Access Compliance Report

Public Rights-of-Way

Intersection ID: 44471	Main Street: COREY_COMMON_AV	Cross Street: REDDING_GLEN_AV	Location: NE
ADA ID: BFC8CF6B238E	Ramp Type: Perp	Initial Pass/Fail: Fail	Overall Compliance: No
Codes/Mitigation Info/Possible Solution		Field Measurements/Component Compliance

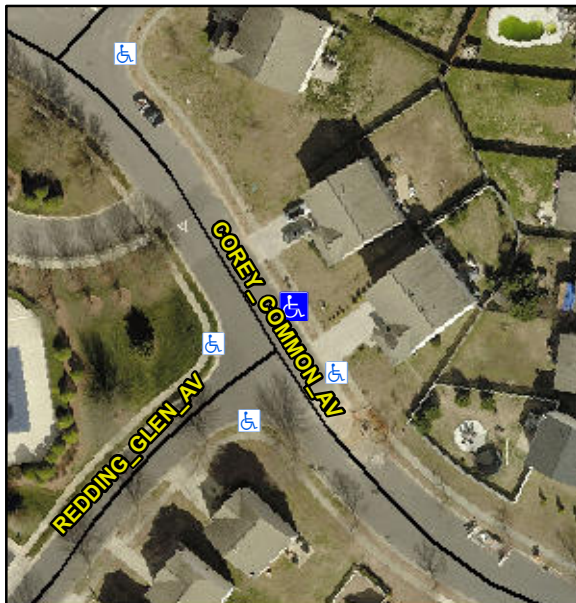
**Not Found, R304.2.2, R304.5.3,
R304.2.1, R304.2.2-Perp, R304.3.2-
Para, R302.7.2, R304.5.4**

Compliance	Description	Data	Compliance	Description	Data
N/A	Ramp Length (in)	48.0	No	Ramp Slope (%)	9.1
Yes	Ramp Width (in)	48.0	No	Ramp XSlope (%)	2.2
N/A	Flare Type LT	N/A	N/A	Flare Type RT	N/A
N/A	Flare Slope LT (%)	N/A	N/A	Flare Slope RT (%)	N/A
N/A	Flare Traversable LT?	No	N/A	Flare Traversable RT?	No
No	Landing Length (in)	N/A	N/A	DWS Provided?	N/A
No	Landing Width (in)	N/A	N/A	DWS Contrast?	N/A
No	Landing Slope (%)	N/A	N/A	DWS Length (in)	N/A
No	Landing X Slope (%)	N/A	N/A	DWS Full Width?	N/A
N/A	Landing Curb? (Y/N)	N/A	N/A	DWS Offset (in)	N/A
N/A	Shared Landing?	N/A			
Yes	Gutter Ponding?	N/A	No	Gutter Slope (%)	N/A
No	Gutter Lip Ht (in)	N/A	No	Gutter X Slope (%)	N/A
N/A	Painted X Walk1?	No	N/A	Painted X Walk2?	N/A
	X Walk 1 Direction	To W		X Walk 2 Direction	N/A
N/A	X Walk 1 Width (in)	N/A	N/A	X Walk 2 Width (in)	N/A
	X Walk 1 Slope (%)	7.1		X Walk 2 Slope (%)	N/A
	X Walk 1 X Slope (%)	2.0		X Walk 2 X Slope (%)	N/A

N/A	Ramp inside XWalk1?	N/A	N/A	Ramp inside XWalk2?	N/A
	Road Slope (%)	N/A	N/A	Clear Space?	N/A
	Road X Slope (%)	N/A	N/A	Clear Space to XWalk (in)	N/A
Yes	Any Obstructions?	N/A	Yes	Storm Grate/Utility Hazard?	N/A
	Obstruction Type			Storm Grate/Utility Type	
		N/A			N/A
			Yes	Surface Condition? (G/P)	Good

**Remove & Replace Entire Ramp.
Remove & Replace Gutter.**
